HISTORICAL ANALYSIS AND DESIGN REVIEW:

Property Address: 16 - 22 N High
Dublin, Ohio 43016

Project Proposal: Construction of a new mixed-use, office/residential/restaurant building that will include a town home and a small business (restaurant) and the demolition of a shed and detached garage.

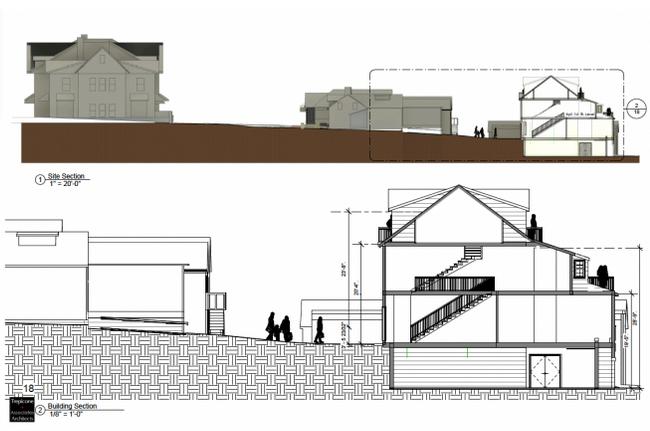
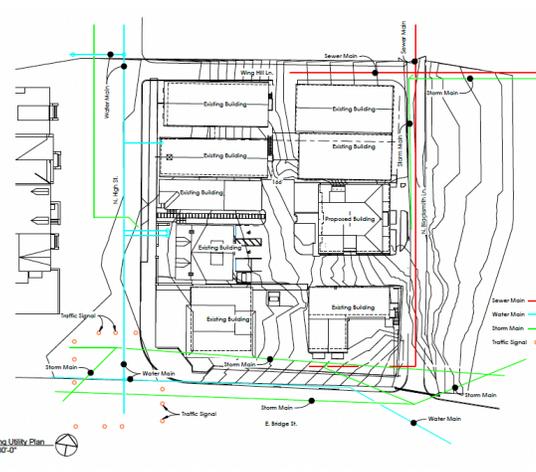
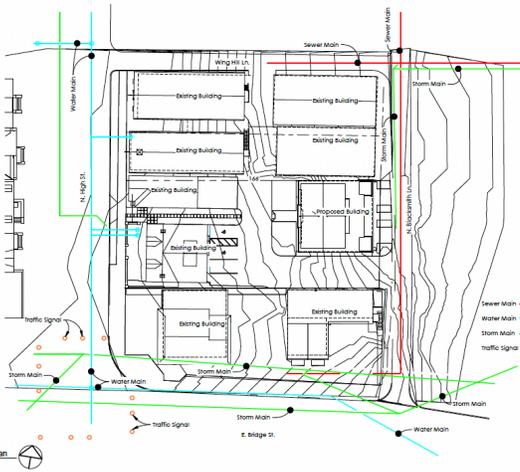
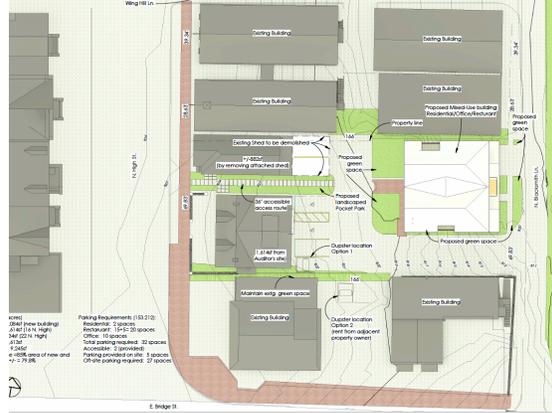
The massing in this rendition is broken down by the use of a double gable roof and the elimination of a full third floor. This creates a more appropriate scale in relationship to the existing historic properties that exist on the property currently.

Additionally, this addresses the concern that the facade facing Blacksmith Lane was out of scale with the residential buildings across the road, facing Riverview.. The elimination of the second garage door and the full third floor on the east elevation creates a more appropriate residential feel than original proposal which was out of scale for the very narrow, alley-like, Blacksmith Lane.

14 West Elevation
3/16" = 1'-0"

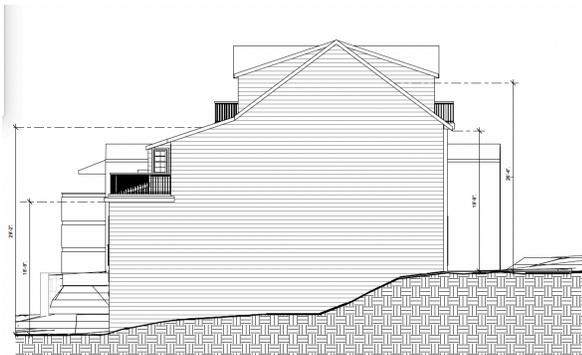
The elimination of the 2nd garage creates a much better frontage to Blacksmith Lane and is more pedestrian. As the design develops there will be opportunities to add human scale through details such as hardscape, lighting, railings, trim details, etc...
